# Program Bulletin

**SB-10055497-8593**

**SUBJECT:** Incorrect Transmission Thrust Bearing

**MODELS:** 2012 Chevrolet Silverado HD  
2012 GMC Sierra HD  
Equipped with Allison 6-Speed Automatic Transmission (MW7)

3723744

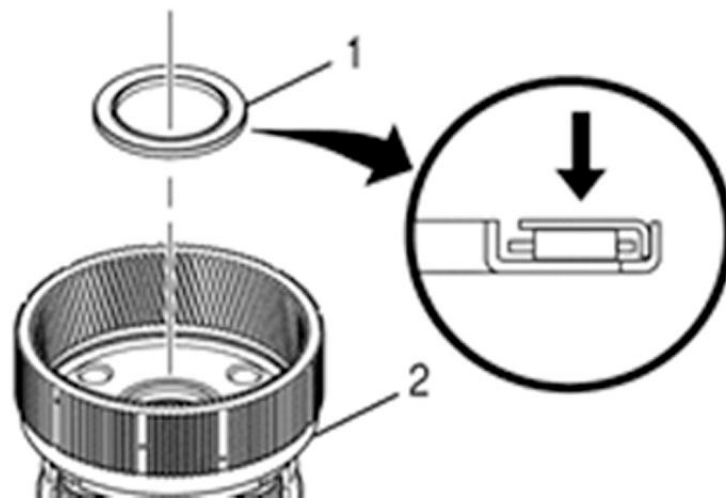
**Caution:** Installing the thrust bearing incorrectly may cause permanent damage to the transmission.

1. Align the thrust bearing (1) so that the black oxide surface on the thrust bearing is facing up, away from the input carrier module (2).
2. Install the thrust bearing (1) onto the input carrier module (2).
